Appendix 2: Recommended amendments

General	
DEV-LI6	<p data-bbox="331 344 577 368">[Insert amended ODP]</p> <p data-bbox="331 411 427 435">Context</p> <p data-bbox="331 443 2029 603">Legacy Reference: Lincoln Outline Development Plan 7 (Appendix 37) Located in close proximity to an established retail destination and within close walking distance to the Town Centre and University, this area provides a unique opportunity for higher density housing. This area has been planned as a single entity, but with the opportunity to be separated into individual blocks for sale and development. The ODP outlines the overall development principles for this area, providing a blueprint guideline for finer-grained design outcomes at the site level.</p> <p data-bbox="331 643 439 667">Land Use</p> <p data-bbox="331 675 2029 730">This development area introduces higher residential densities in immediate proximity to the existing supermarket (an established retail destination) and Gerald Street, which is the central street of the Lincoln township.</p> <p data-bbox="331 738 2029 930">The area has the potential to achieve a density in excess of 20 households per hectare. It will comprise a residential dev

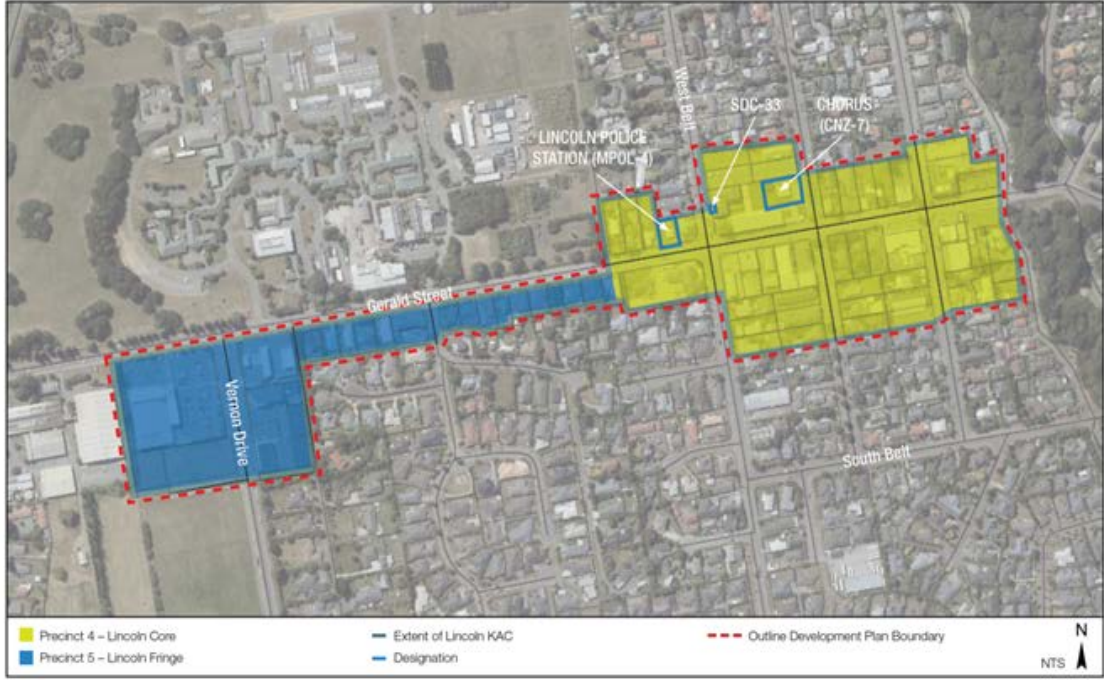
Transitions are required between the shared surface part of the road and the adjacent 'standard' roading network to inform drivers that they are entering a different road environment. These will be provided within the short sections of road which lie between Vernon Drive and the shared space, and will each include a reduction in usable carriageway width, a visual narrowing of the carriageway, a change in road surface, and/or a vertical deflection feature such as a speed table.

The shared space which runs through the majority of the site will be designed in a manner that does not use any upstand or level change to differentiate between the carriageway and footpath. Rather, it will be designed and constructed so that the same (or similar) level is maintained between the edge of the buildings fronting the eastern side and western side of the road reserve, as well as on the portion of the road used by pedestrians and motorised vehicles. The legal extent of the road reserve will be clearly delineated through the use of street furniture, different coloured surfacing, minor grade changes and/or other method that does not use a kerb upstand or similar sudden grade change. Further, if any changes of grade are included within the shared space, these will be designed in a manner that does not present a tripping hazard to the blind or partially sighted. Sufficient cross fall will be provided within the road reserve to effectively manage stormwater.

The shared space will provide a route to allow the movement of motorised vehicles, which will be designed in a way that can accommodate the passage of a standard refuse collection truck. This route will be clearly delineated to ensure that drivers are appropriately informed of the areas that they are expected to travel within by using methods such as street furniture, landscaping, and varying paving surfaces. The route will be designed in a manner which encourages slow vehicle speeds through providing elements such as tight curve radii at intersections, a curvilinear alignment or careful placement of on-street parking spaces.

The linear reserve provides for pedestrian and cyclist circulation between the east and west boundaries of the site. It also creates a strong sense of amenity for adjoining residential development and provides beneficial open space to potential denser built form and creates more permeable blocks. It shall have a minimum width of 10m to allow for later alignment design flexibility depending on the urban grain arrangement. This is sufficient width to accommodate a footpath and vehicle access for maintenance purposes.

A 3m wide planting strip shall be provided along the eastern boundary with Vernon Drive. This width is to provide space for the establishment of a near continuous windbreak of trees to this boundary.

A stormwater easement of approximately 3m in width is present along the western boundary of the development area. This will accommodate an underground reticulated stormwater system and dished overflow path along its surface. Permanent access is required along its length for maintenance purposes by the Council. Planting within this width will be limited. Ownership of this strip may be private (together with associated easement access), or, if this is a part of a
